Addendum

DSP56309UMAD/D
Rev. 1, 11/2002

DSP56309 User's
Manual Addendum

Figure D-2. Operating Mode Register (OMR)

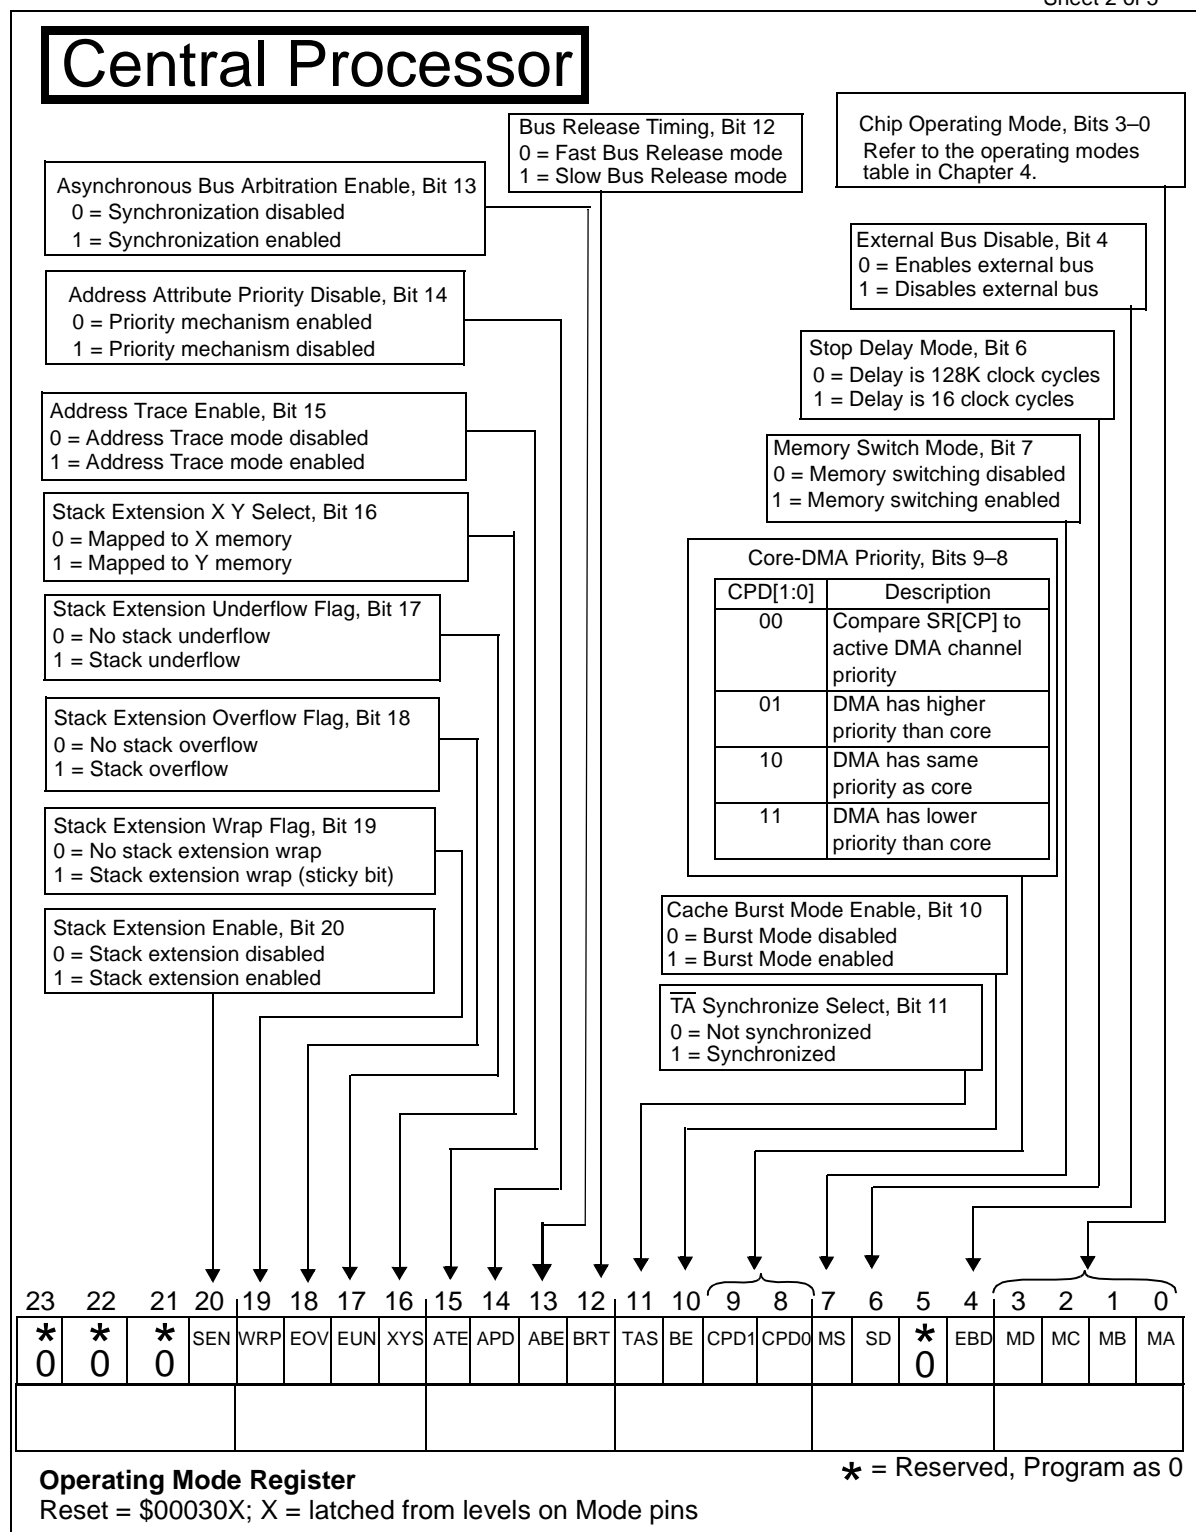
Use the following examples to replace **Figure D-2** and **Figure D-21** in the *DSP56309 User’s Manual*.
